SUBJECT: ISSUANCE OF AMENDMENT NO. 153 TO FACILITY OPERATING LICENSE NO. DPR-62,
BRUNSWICK STEAM ELECTRIC PLANT, UNIT 2, REGARDING FUEL CYCLE NO. 8 -
RELOAD EXTENDED BURNUP FUEL (TAC NO. 66155)

AMENDMENT NO. 153 TO FACILITY OPERATING LICENSE NO. DPR-62 - BRUNSWICK, UNIT 2

ATTACHMENT TO LICENSE AMENDMENT NO. 153

Figure 3.2.1-1

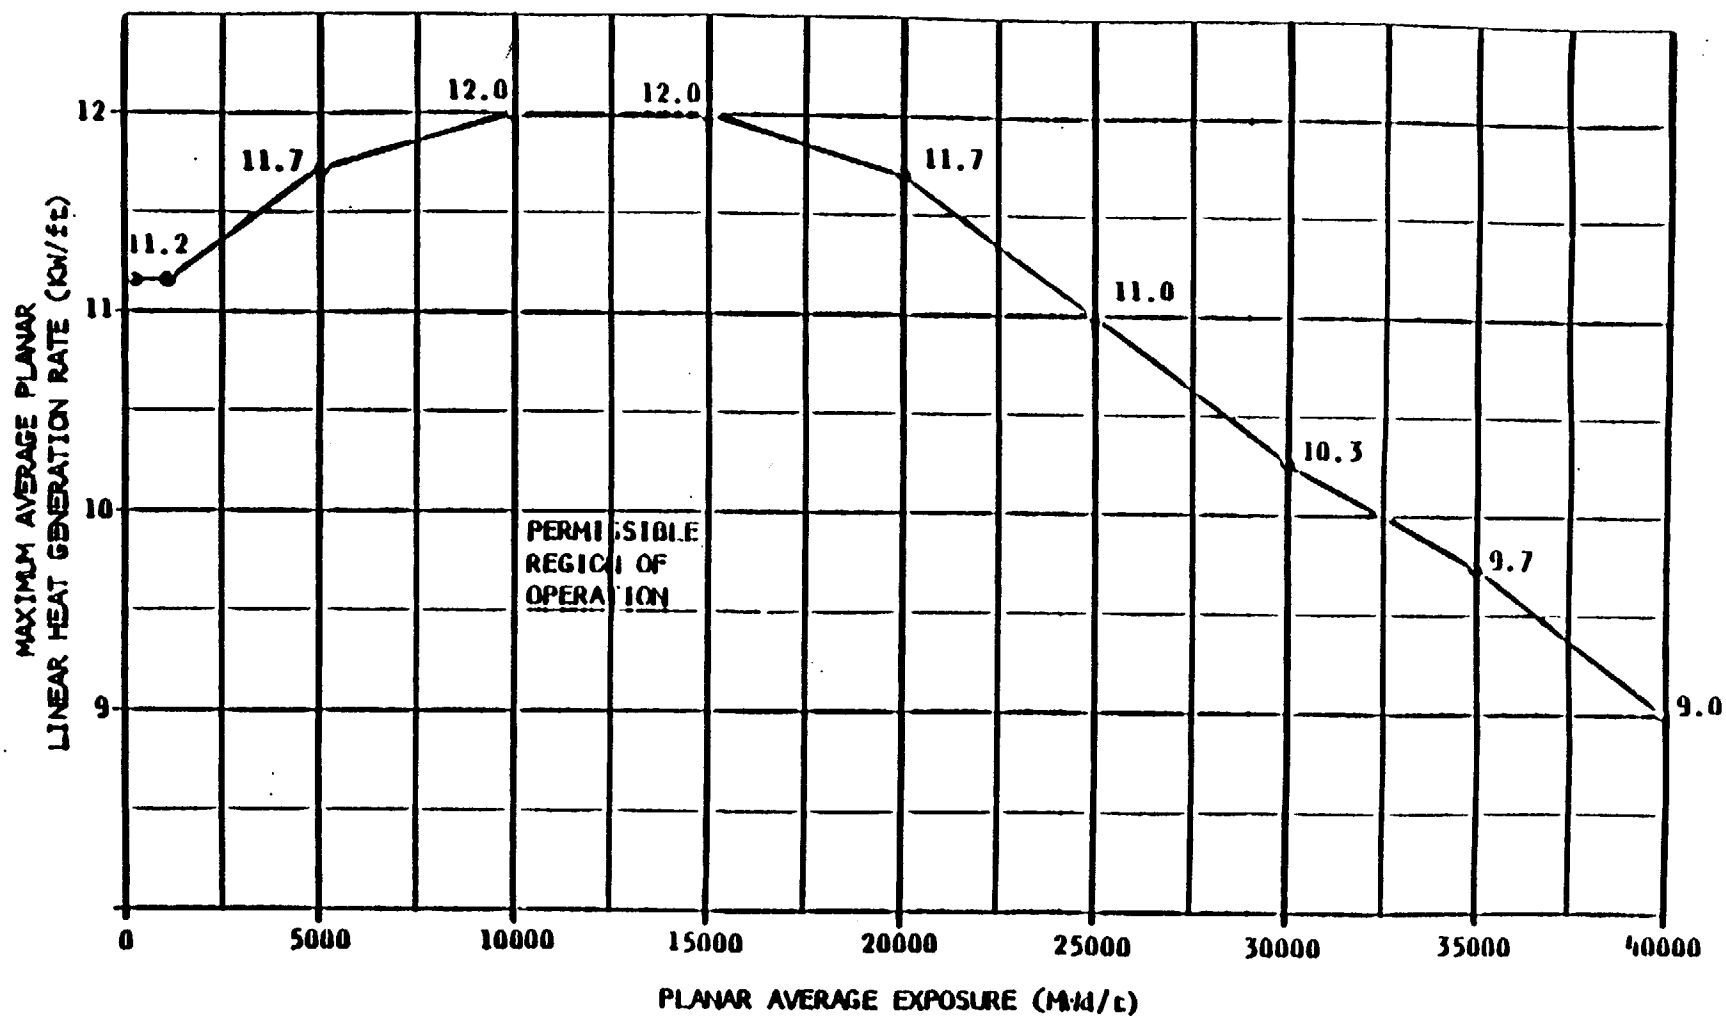
Amendment No. 149, issued April 8, 1988, changed the TS to incorporate the operating limits for all fuel types for Cycle 8 operations of BSEP-2. In addition, the definitions for CRITICAL POWER RATIO and PHYSICS TESTS were revised. As part of that amendment request, fuel burnups could exceed 33,000 MWD/MT. However, Amendment 149 limited fuel burnup to 33,000 MWD/MT until the staff could assess certain environmental aspects of the higher burnup. The staff completed its review of the environmental effects of the fuel handling accident and transportation of fuel with burnups beyond 33,000 MWD/MT and finds the extended burnup fuel acceptable. Therefore, the footnote that was added to TS Figure 3.2.1-1 through 3.2.1-5 in Amendment 149 is deleted.
